Access Compliance Report

Public Rights-of-Way

(Curb Ramps)

Intersection ID: 13960	Main Street: CENTRAL_AV	Cross Street: KILBORNE_DR	Location: SW
ADA ID: 69A1DE1AA722	Ramp Type: Perp	Initial Pass/Fail: Fail	Overall Compliance: No
Severity Score: 8.75			
Codes/Mitigation Info/Possible Solution		Field Measurements/Component Compliance

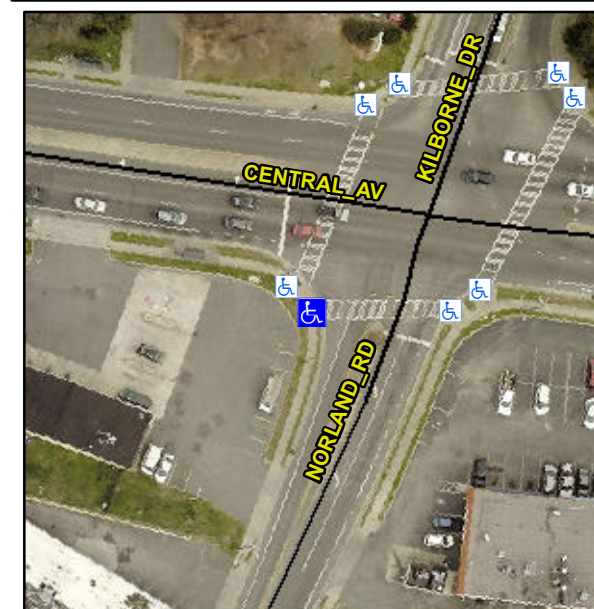
Not Found, R304.5.1

Compliance	Description	Data	Compliance	Description	Data
N/A	Ramp Length (in)	24.0	Yes	Ramp Slope (%)	7.0
No	Ramp Width (in)	45.0	Yes	Ramp XSlope (%)	0.5
N/A	Flare Type LT	N/A	N/A	Flare Type RT	N/A
N/A	Flare Slope LT (%)	N/A	N/A	Flare Slope RT (%)	N/A
N/A	Flare Traversable LT?	N/A	N/A	Flare Traversable RT?	N/A
N/A	Landing Length (in)	N/A	N/A	DWS Provided?	N/A
N/A	Landing Width (in)	N/A	N/A	DWS Contrast?	N/A
N/A	Landing Slope (%)	N/A	N/A	DWS Length (in)	N/A
N/A	Landing X Slope (%)	N/A	N/A	DWS Full Width?	N/A
N/A	Landing Curb? (Y/N)	N/A	N/A	DWS Offset (in)	N/A
N/A	Shared Landing?	N/A			
N/A	Gutter Ponding?	N/A	N/A	Gutter Slope (%)	N/A
N/A	Gutter Lip Ht (in)	N/A	N/A	Gutter X Slope (%)	N/A
N/A	Painted X Walk1?	Yes	N/A	Painted X Walk2?	N/A
	X Walk 1 Direction	To E		X Walk 2 Direction	N/A
N/A	X Walk 1 Width (in)	107.0	N/A	X Walk 2 Width (in)	N/A
	X Walk 1 Slope (%)	1.2		X Walk 2 Slope (%)	N/A
	X Walk 1 X Slope (%)	0.0		X Walk 2 X Slope (%)	N/A

Remove & Replace Entire Ramp.
